**CLINCH RIVER
BREEDER REACTOR PROJECT**

**PRELIMINARY
SAFETY ANALYSIS
REPORT**

PROJECT MANAGEMENT CORPORATION

Figure Q001.539-2

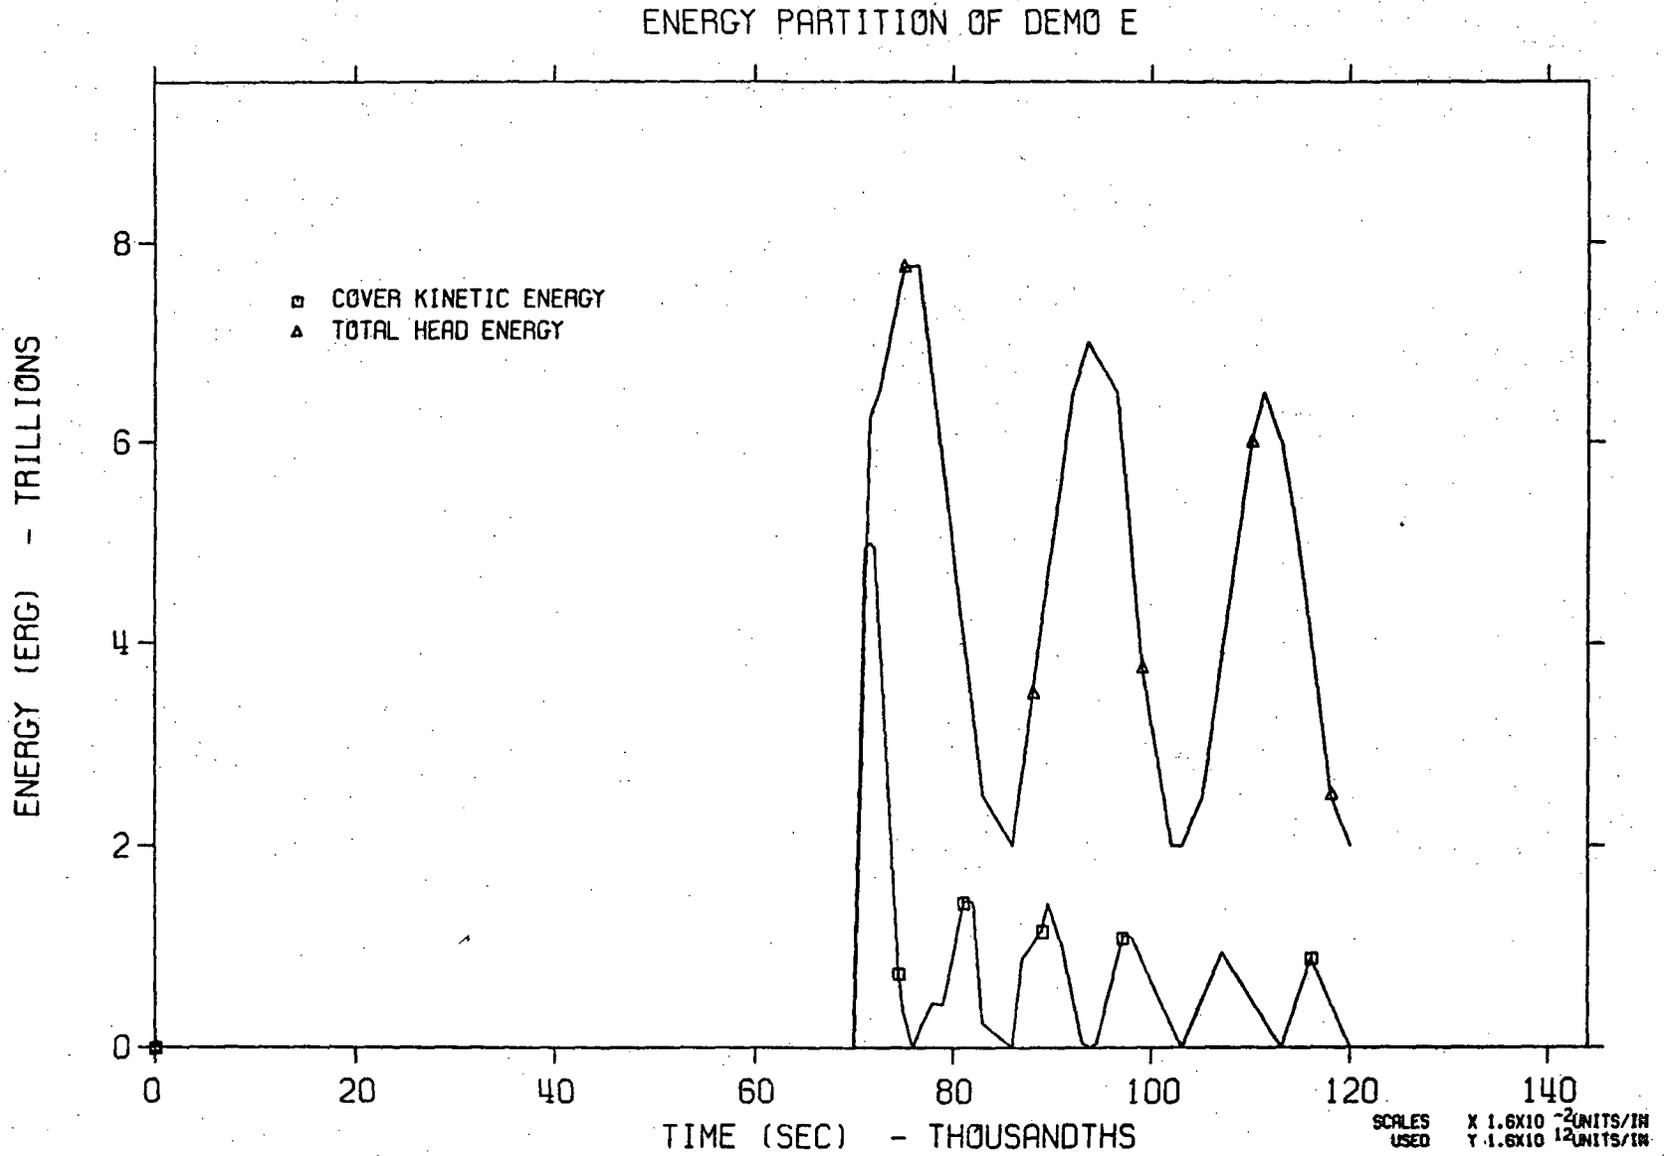
Question 001.539 (F6.3.2.3)

The energy partition curves as a function of time are presented in Figure Q001.539-1 and Figure Q001.539-2. Figure Q001.539-1 contains the energy curves of axial positive kinetic energy (sodium slug), core barrel strain energy, vessel strain energy, head kinetic energy (rotating plugs) and total head energy. Since the rotating plugs are modeled as a rigid body in REXCO analysis, the difference between the total head energy and head kinetic energy will be the strain energy of vessel holddown bolts. The support ledge is modeled as a rigid foundation in REXCO, therefore there is no strain energy associated with it. The core support is modelled as a flat thick plate. The energy curve associated with this model is not provided here because the model is not considered as representative to provide the strain energy of the support. (The purpose of the model is to reflect a conservative load on the core support.) Figure Q001.539-2 is an enlarged version of head kinetic energy and total head energy.

FIGURE Q001.540-1

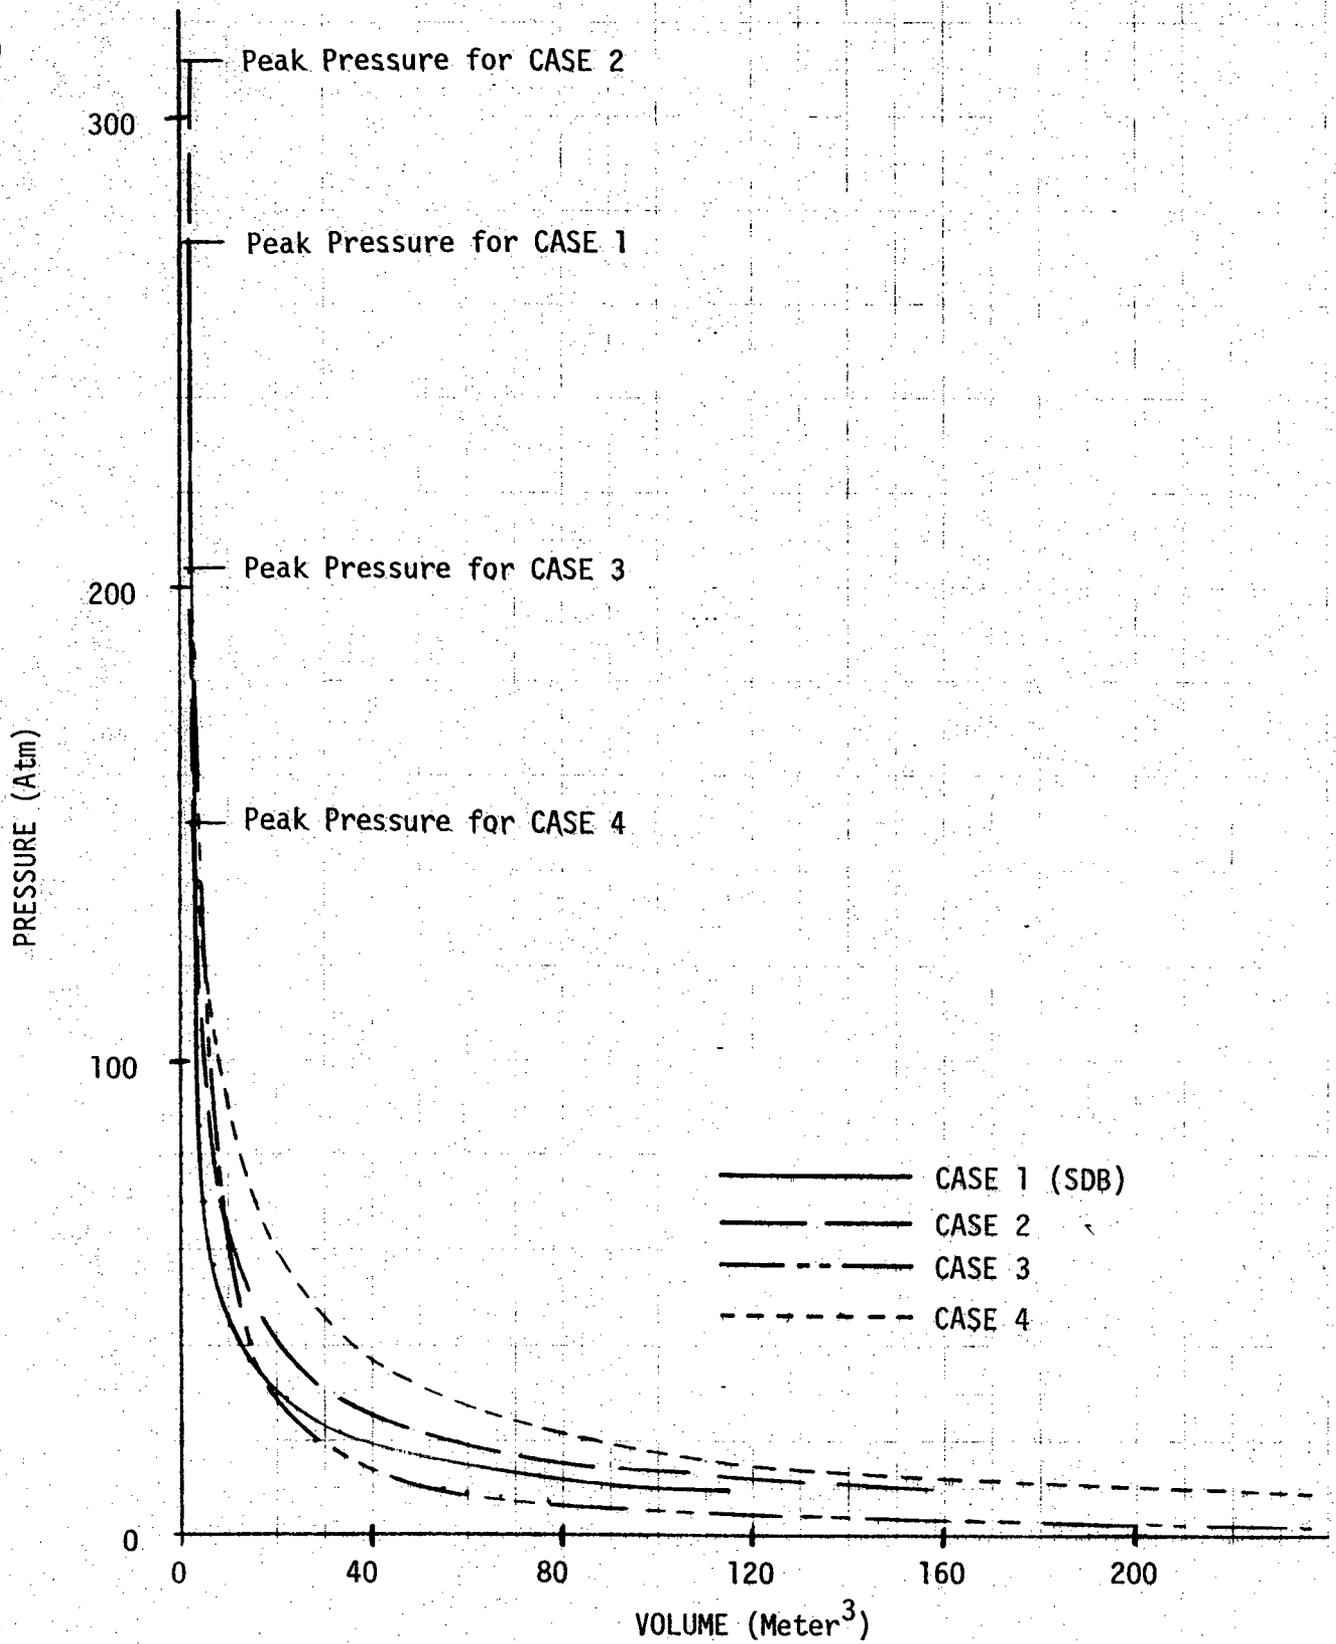
Question 001.540 (F6.3.1)

The work energy values in the above four cases should only be considered as convenient labels for the cases rather than as a measure of the severity of the events. Table Q001.540-1 summarizes the principal characteristics of these four cases. Figure Q001.540-1 provides the p-v curves for all four cases. Cases 1 and 2 are considered to be more representative of the potential loading conditions which result in a pessimistic treatment of phenomena (divergent from experimental data) associated with hypothesized energetic core disruptive accidents than cases 3 and 4. This is due to the fact that Case 3 hypothesizes sodium vapor as the working fluid, which is contrary to experimental evidence and Case 4 hypothesizes a uniform temperature distribution, which is arbitrary.
